Memorandum for: U.S. Army Corps of Engineers (Corps), Portland District, Operations Division, Regulatory Branch (Taylor), Regulatory File No. NWP-2000-984(2).

Subject: Portland Sediment Evaluation Team (PSET) Technical Memorandum Re: review of the Port of Portland's (Port's) July 11, 2012 Level 2 "Sediment Characterization Report Terminal 4 Berths 401 and 410, 11040 North Lombard Street, Portland, Oregon" (SCR); and the July 24, 2012 "Work Plan to Address NSM Sediments Terminal 4 Berths 410 – Mid and East Berth Areas 11040 Lombard Street Portland Oregon" (NSM Work Plan). Terminal 4 (T4) is located on the east bank of the Willamette River, between river miles (RMs) 4.0 and 5.5, in Portland, Multnomah County, Oregon.

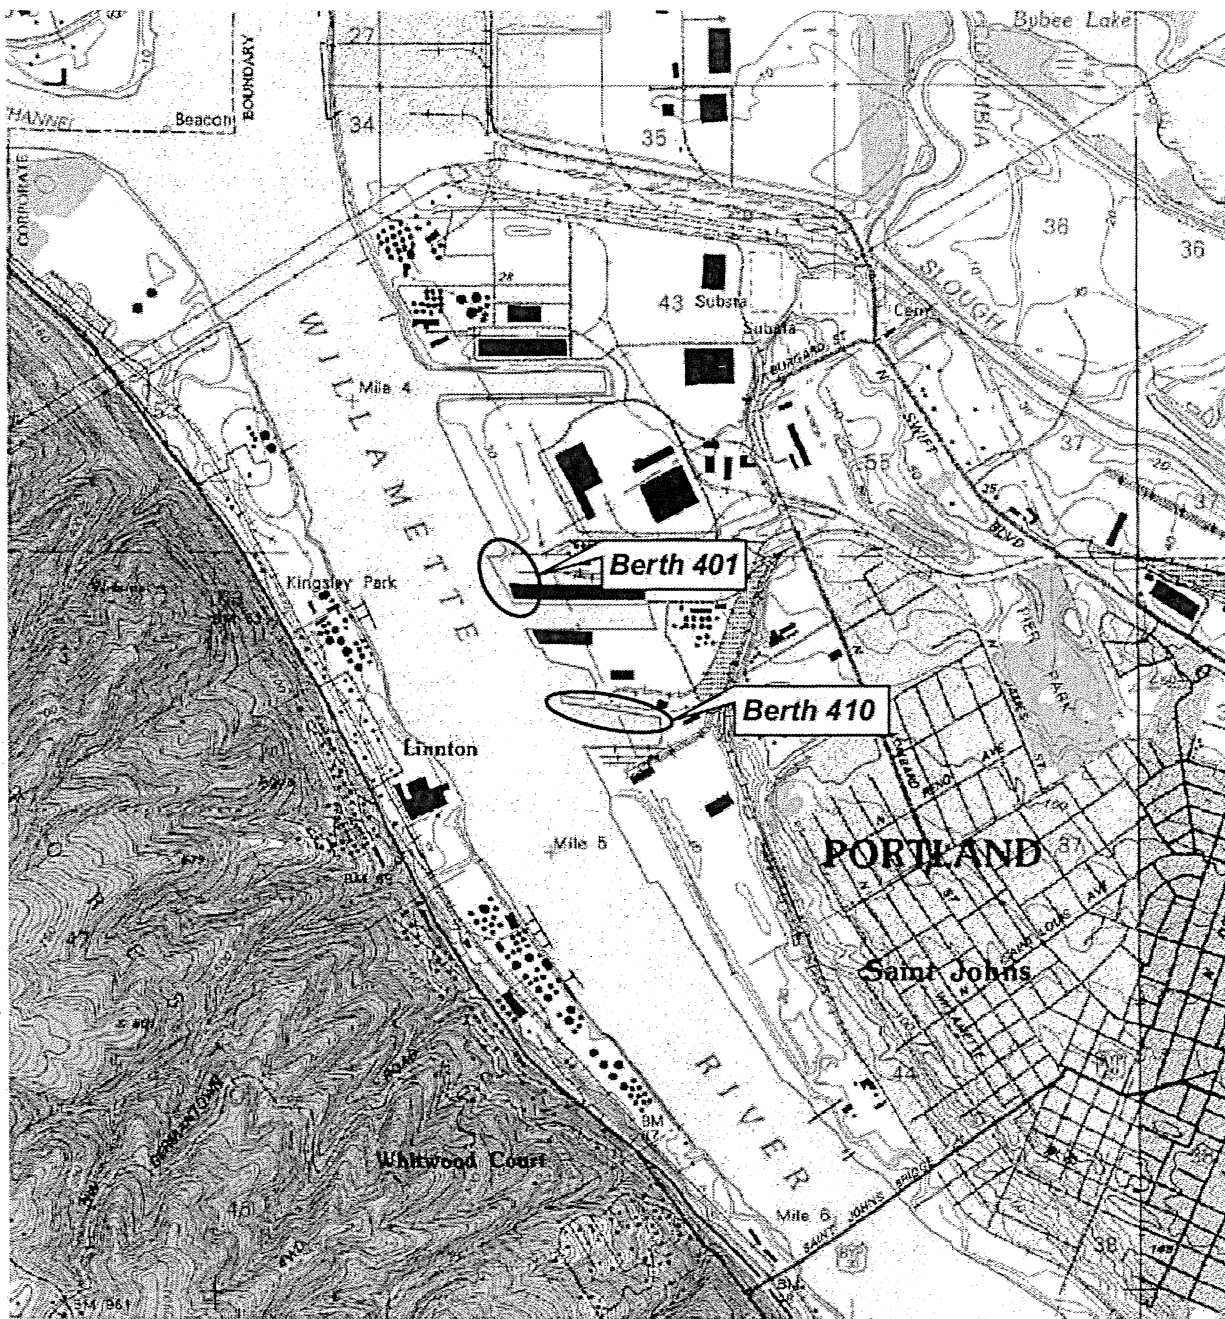
How much dredge in Cell?

Figure 4. Post-dredge grab sample locations, Berth 410.

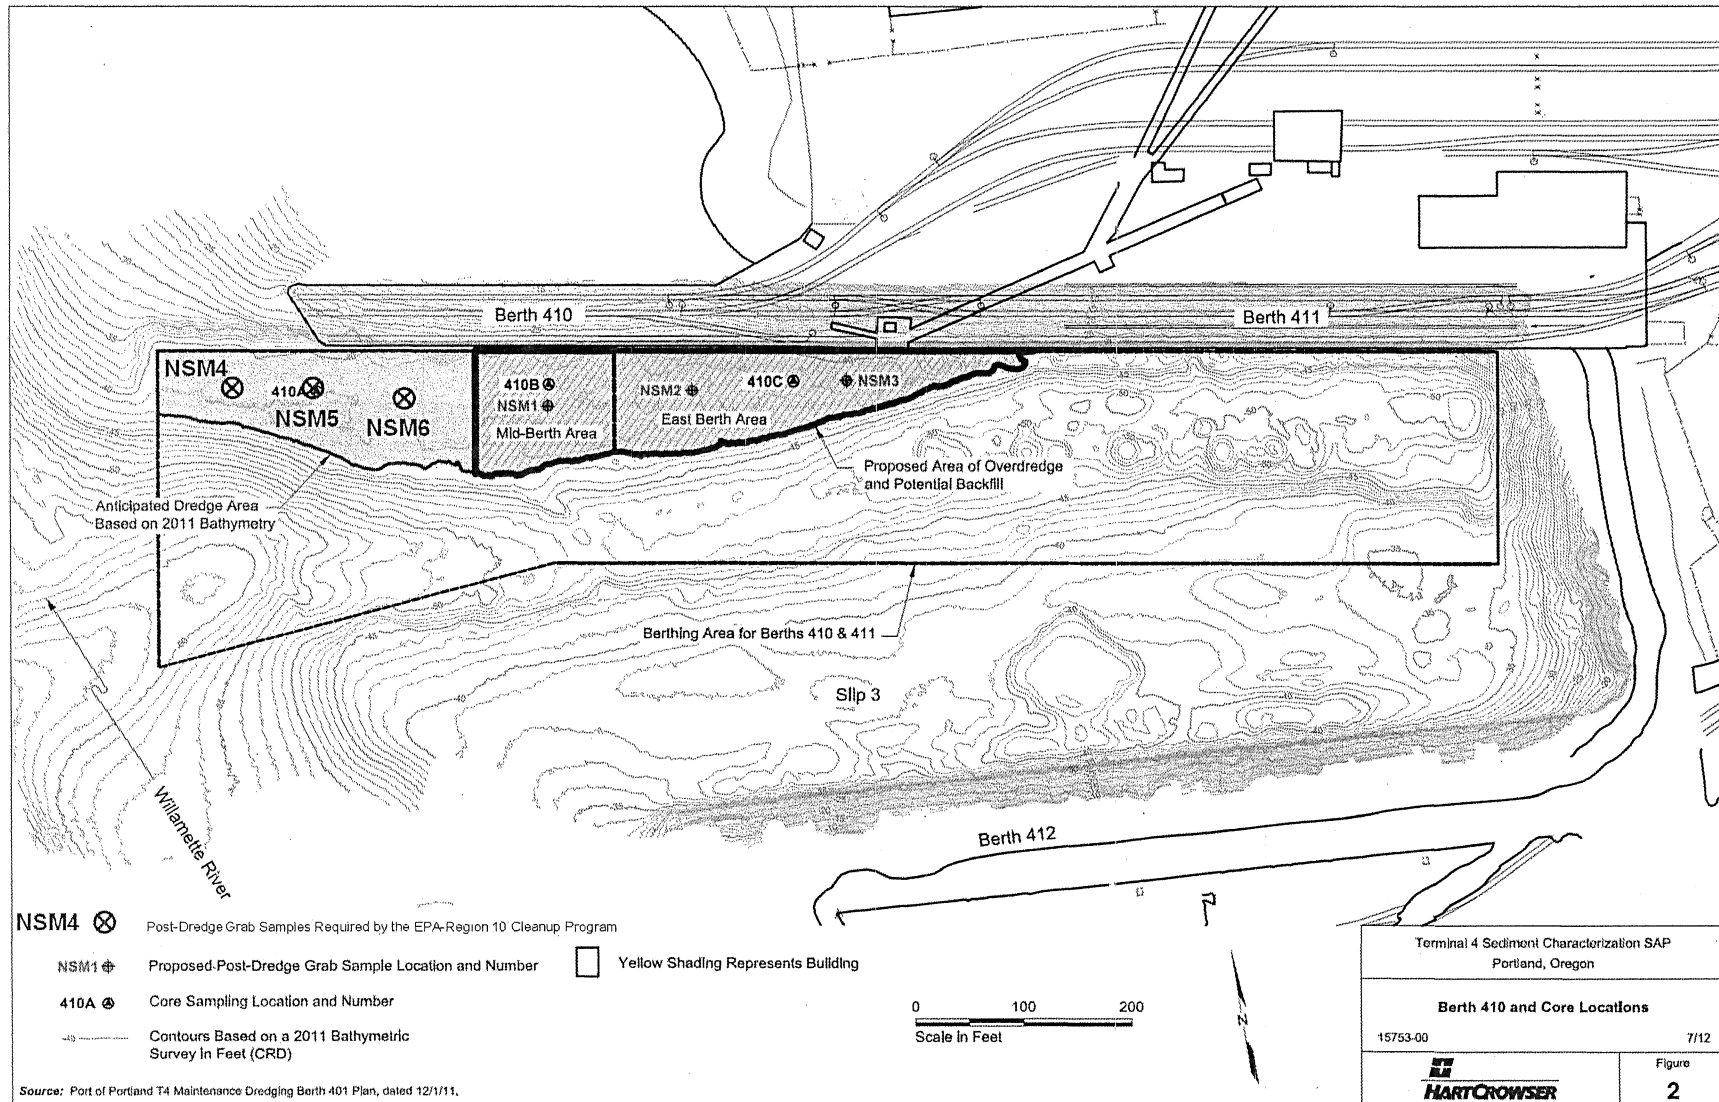
- Over-dredge the NSM below the inner-berth DMMU and a portion of the mid-berth DMMU to a depth of -44 feet CRD (i.e., to the maximum depth characterized) (Figure 4).
- After dredging, the Port would conduct post-dredge sampling in the over-dredged area.
- If SLs are still exceeded, the Port would place a layer of sand backfill in those areas to control and reduce the aquatic exposure of these sediments to the aquatic environment after dredging.

The western boundary of the over-dredge area extends approximately 500 to 520 feet west of the eastern boundary of the estimated limit of the dredge area, including a portion of the mid-berth DMMU represented by sample 410B/NSM (Figure 4). Extending the over-dredge area west into this DMMU was done in consideration of the benzo(b+k)fluoranthene exceedance.

1. All post-dredge grab samples need to be analyzed for total metals, PAHs, PCBs, and pesticides.
2. In addition to the three surface grab samples proposed in the NSM Work Plan, the Port must collect three additional surface grab samples in the western berth area (characterized by samples 410A/DP and 410A/NSM) (Figure 4):
 - a. One sample must be collected from sample station 410A (sample NSM5).
 - b. Two additional samples need to be located to the east and west of the sample NSM5 location (samples NSM6 and NSM4, respectively).

1. The PSET requests that any sand cover placed in the over-dredge area be a *minimum* thickness of six inches.
2. In order to better understand the process by which the Port would place a sand cover, the PSET requests that the Port delineate the sand backfill cells described in Section 3.3 of the NSM Work Plan.
3. To create a record of compliance, the PSET requests that the Port prepare an after-action report that describes the following parameters:
 - a. Dredge volumes (both berths)
 - b. Dredging extent (horizontal and vertical, in both berths)
 - c. Sample locations and analytical results (Berth 410)
 - d. Figure delineating backfill cells and average backfill thickness in each cell (Berth 410)
